**City of Portland, Maine – Building or Use Permit Application** 389 Congress Street, 04101, Tel: (207) 874-8703, FAX: 874-8716

Location of Construction: 207 Lane Ave. 04103		Owner: Raphael Radziewicz		Phone:		Permit No: <b>990639</b>	
Owner Address: 207 Lane Ave. 04103		Lessee/Buyer's Name:		Phone:		Business Name: <i>Refer Reali</i>	
Contractor Name: <i>David Dardano</i> <del>*ABC Painting &amp; Contractors*</del>		Address: <i>878-3922 changed 2/20/00</i>		Phone: 753-5104 <i>892-7013</i>		* 892-0412- A1	
Past Use: Single Family		Proposed Use: Same		COST OF WORK: \$ 40,000.00		PERMIT FEE: \$ 200.00	
				FIRE DEPT. <input type="checkbox"/> Approved <input type="checkbox"/> Denied		INSPECTION: Use Group <i>A-3</i> Type: <i>53</i> <i>DOC 46</i>	
Proposed Project Description: Construct 9'x20' Addition 13'x20' Breezeway 20'x20' Garage 4'x12' Porch		Signature:		Signature: <i>[Signature]</i>		Zone: <i>308-A-053</i>	
Permit Taken By: GD		Date Applied For: JUNE 11th, 1999		PEDESTRIAN ACTIVITIES DISTRICT (P.A.D.) Action: Approved <input type="checkbox"/> Approved with Conditions: <input type="checkbox"/> Denied <input type="checkbox"/>		Zoning Approval: Special Zone or Reviews: <input type=

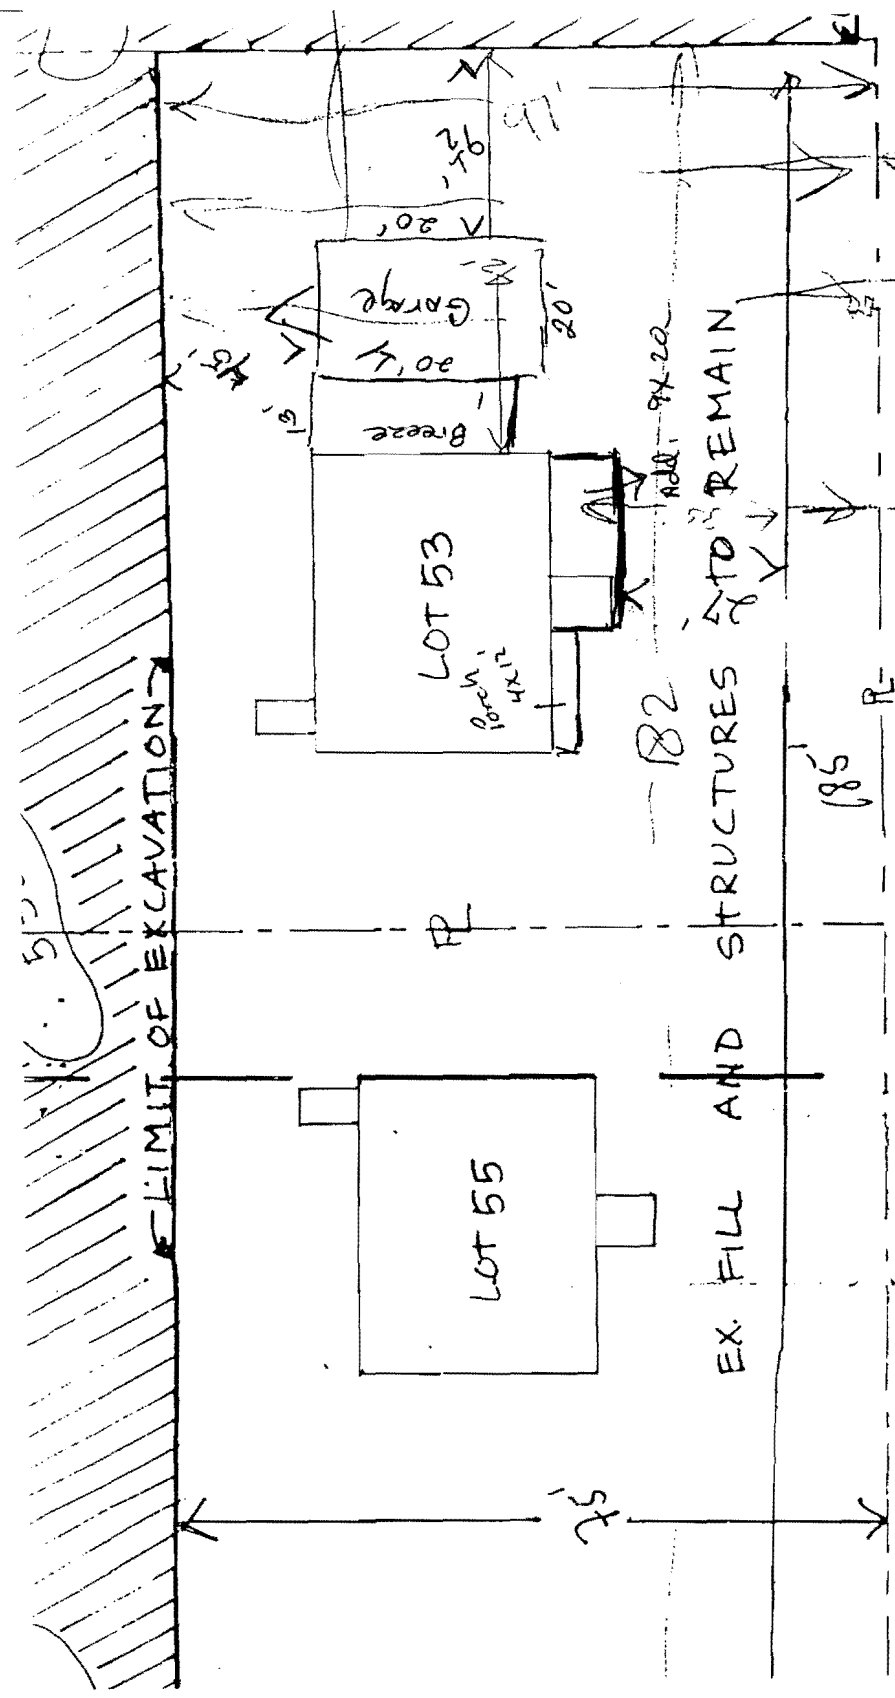
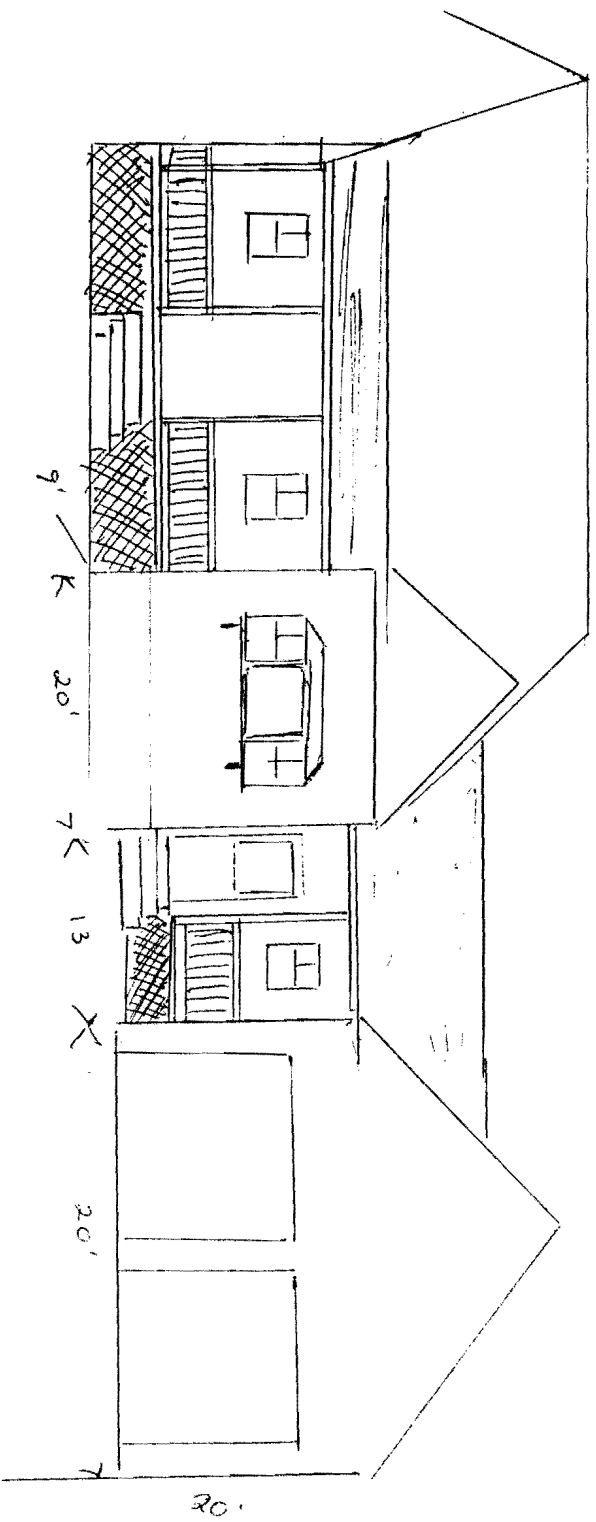
Front Yard - 25' req - 27' shown

Rear Yard - 25' req 45' shown

Side Yard - 0' req - 9 1/2' shown

Lot Coverage/ Impervious Surface - 25% max allowed or 2312.5 sq ft

ext. way	24 x 32 =	768
	13 x 20 =	260
	20 x 20 =	400
	9 x 20 =	180
	7 x 12 =	84
		<hr/>
		1656 sq ft
